SUBJECT: ISSUANCE OF EMERGENCY AMENDMENT FOR THE PALO VERDE NUCLEAR  
GENERATING STATION UNIT NO. 2

The Commission has issued the enclosed Amendment No. 94 to Facility Operating License No. NPF-51 for the Palo Verde Nuclear Generating Station (PVNGS), Unit No. 2. The amendment consists of changes to the Technical Specifications (TS) in response to your application dated March 23, 1996.

Amendment No. 94  
License No. NPF-51

SAFETY EVALUATION BY THE OFFICE OF NUCLEAR REACTOR REGULATION  
RELATED TO AMENDMENT NO. 94 TO FACILITY OPERATING LICENSE NO. NPF-51

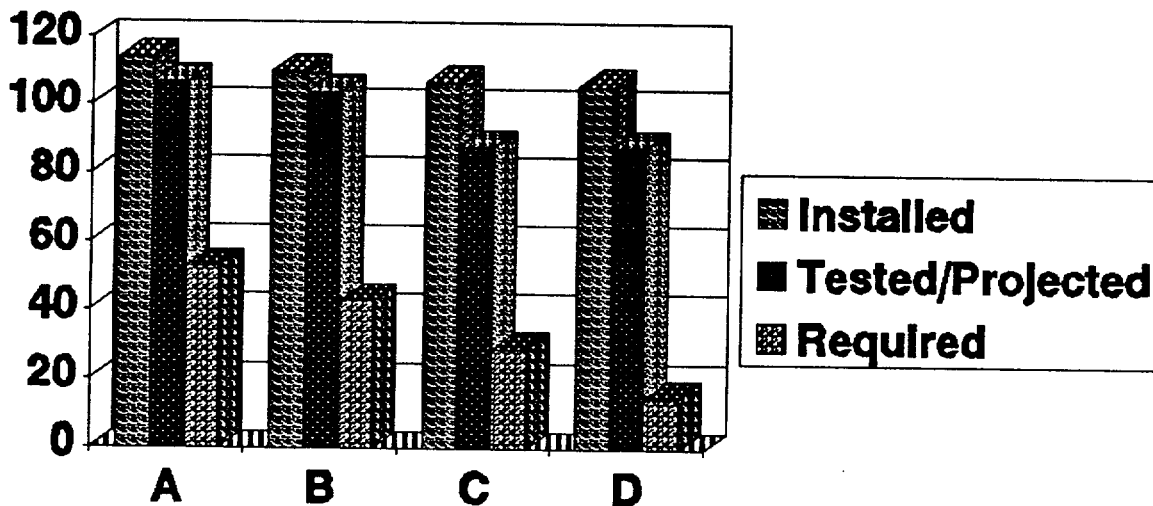
Although battery capacity is less than required by TS 4.8.2.1.e, sufficient capacity remains for the batteries to perform their intended function. The following graph demonstrates the margin in capacity based on projected capacity and actual capacities.

In the most limiting case, the C battery still has greater than 50 percent margin between the projected and required capacities. Therefore, the proposed change to battery capacity requirements does not involve a significant reduction in a margin of safety.
